## *Memorandum*

SUBJECT: **REGULATING PLAN WITH A MAJOR WARRANT FOR A TOWNHOME DEVELOPMENT**

### REGULATING PLAN

#### FOR FAIRVIEW TOWNHOMES

### SECTION A-A

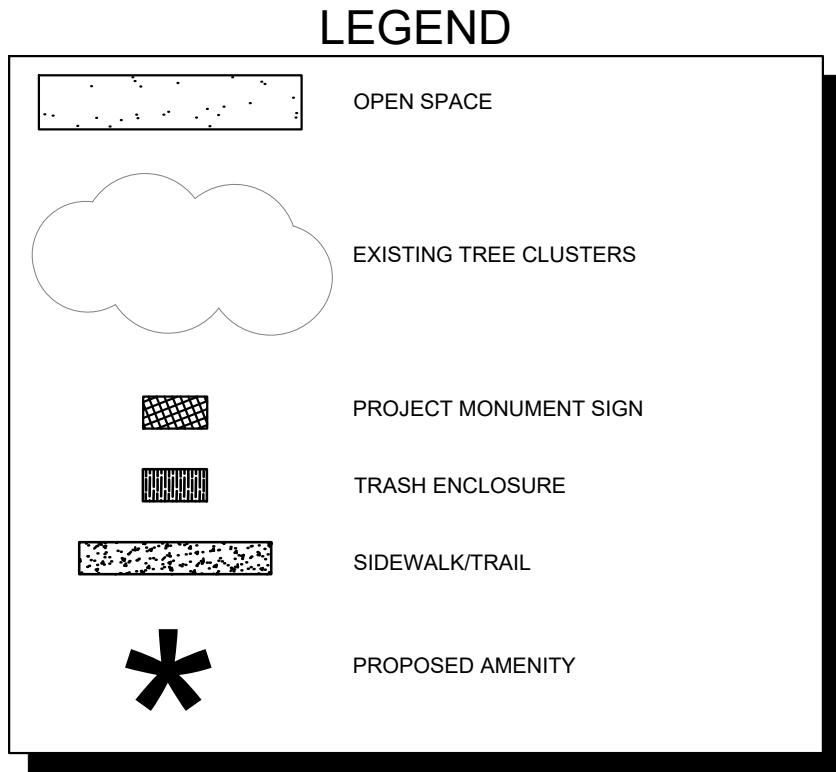
To accommodate for this conflict within the code and the existing design of Fairview Parkway, the Regulating Plan requests a revised BTZ of 0-15.5 feet along Fairview Parkway only. The geometry of the requested maximum 15.5' Build-to-line aligns with the code, if the BTZ were measured from the front property line. The requested minimum zero minimum built-to-line gives the design flexibility on the placement of the front facades of the townhome buildings, especially along this portion of Fairview Parkway that is curved (exclusive of any easements and/or infrastructure conflicts).

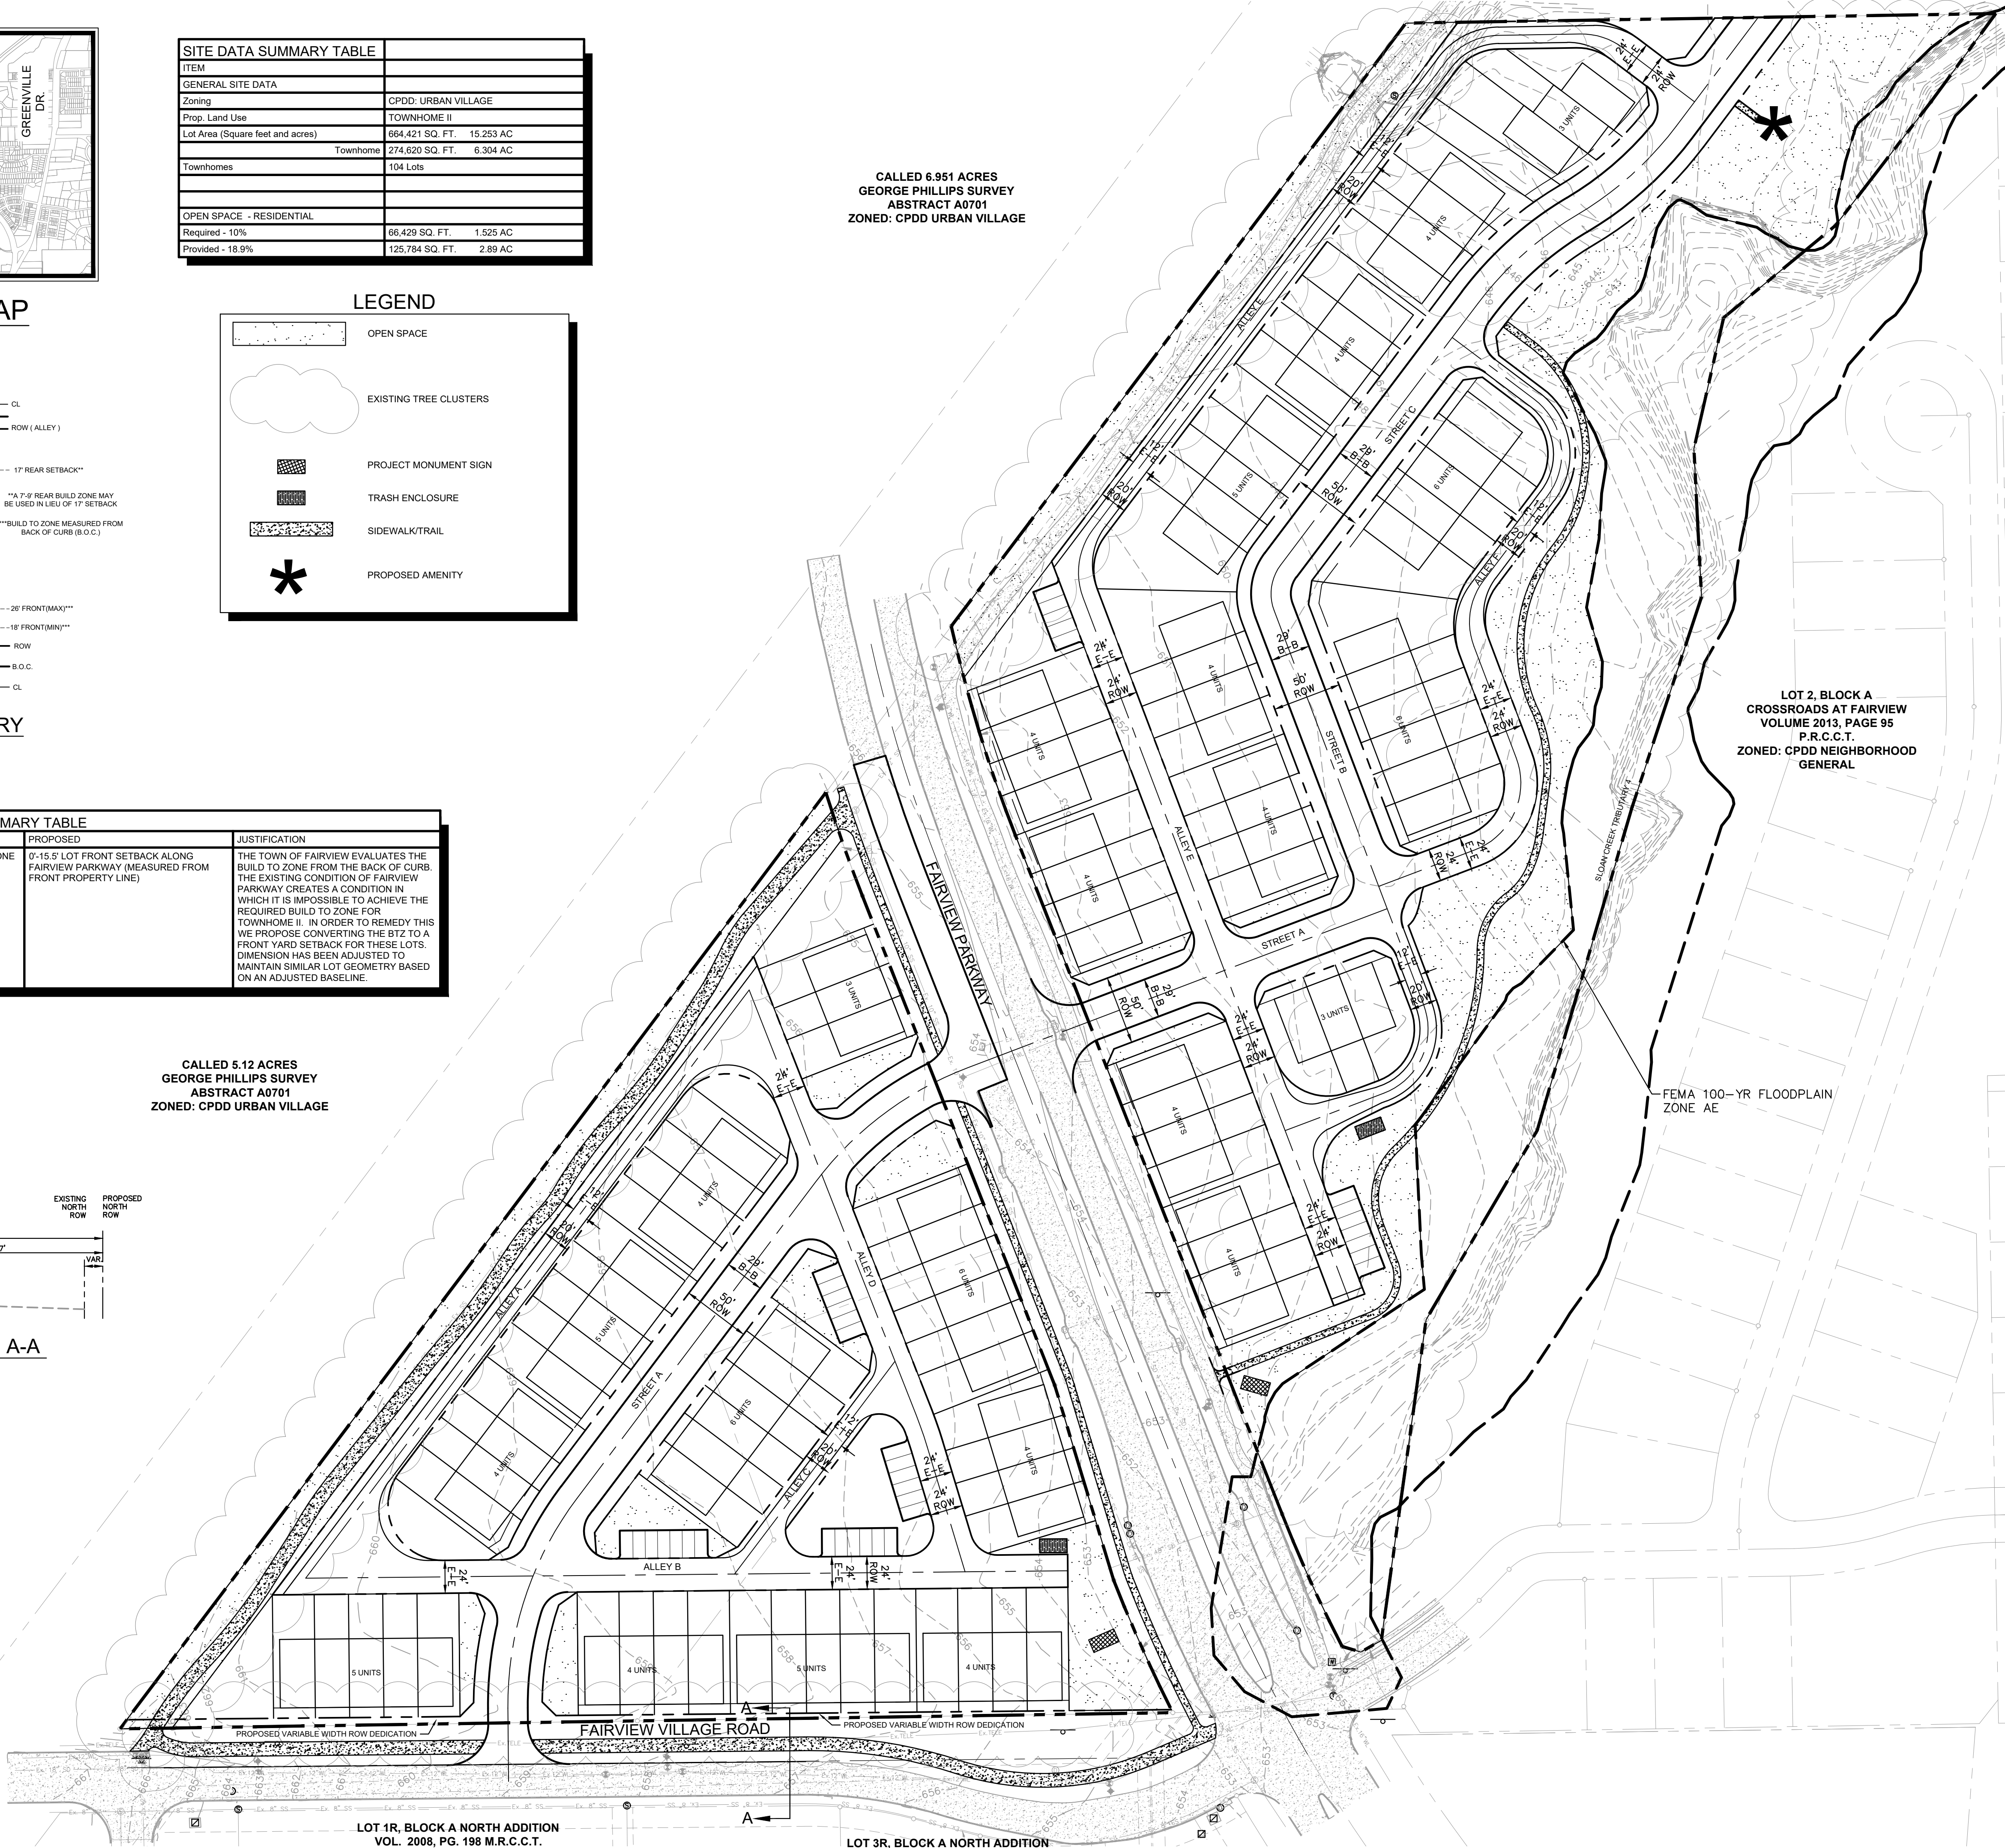
#	ITEM	REQUIREMENT	PROPOSED	JUSTIFICATION
1	TOWNHOME II BUILD TO ZONE (BTZ)	18'-26" BUILD TO ZONE (MEASURED FROM BACK OF CURB)	0'-15' LOT FRONT SETBACK ALONG FAIRVIEW PARKWAY (MEASURED FROM FRONT PROPERTY LINE)	THE TOWN OF FAIRVIEW EVALUATES THE BUILD TO ZONE FROM THE BACK OF CURB. THE EXISTING CONDITION OF FAIRVIEW PARKWAY CREATES A CONDITION IN WHICH IT IS IMPOSSIBLE TO ACHIEVE THE REQUIRED BUILD TO ZONE FOR TOWNHOME II. IN ORDER TO REMEDY THIS WE PROPOSE CONVERTING THE BTZ TO A FRONT YARD SETBACK FOR THESE LOTS. DIMENSION HAS BEEN ADJUSTED TO MAINTAIN SIMILAR LOT GEOMETRY BASED ON AN ADJUSTED BASELINE.

**RECOMMENDATION:** Staff recommends **APPROVAL** of the subject major warrants subject to the following conditions:

1. Site shall be development generally in accordance with the attached regulating plan exhibits
